ALERT SERVICE BULLETIN

REPLACEMENT OF FUEL PUMP

FOR ROTAX[®] ENGINE TYPE 912 (SERIES)

SB-912-053

(see Fig.1)

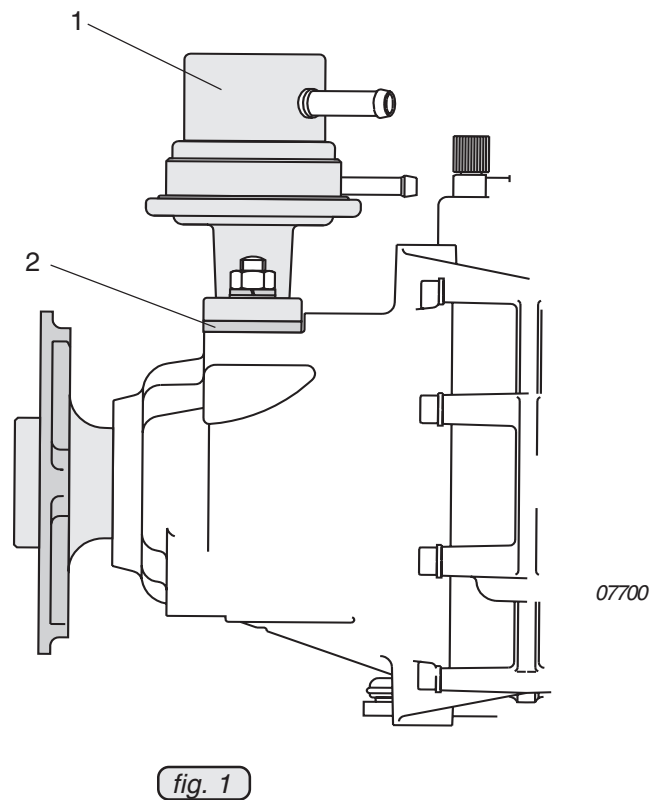
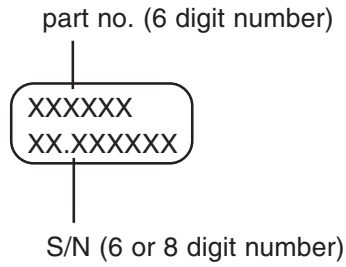
3.1.1) Replacement of the fuel pump

1. Remove fuel pump (1).
2. Gasket (2) replaced by new part.

■ **CAUTION:** Install new gasket supplied with new fuel pump. The thickness is different.

3. Install fuel pump. Tightening torque 15 Nm (133 in.lb).
4. Install fuel line.
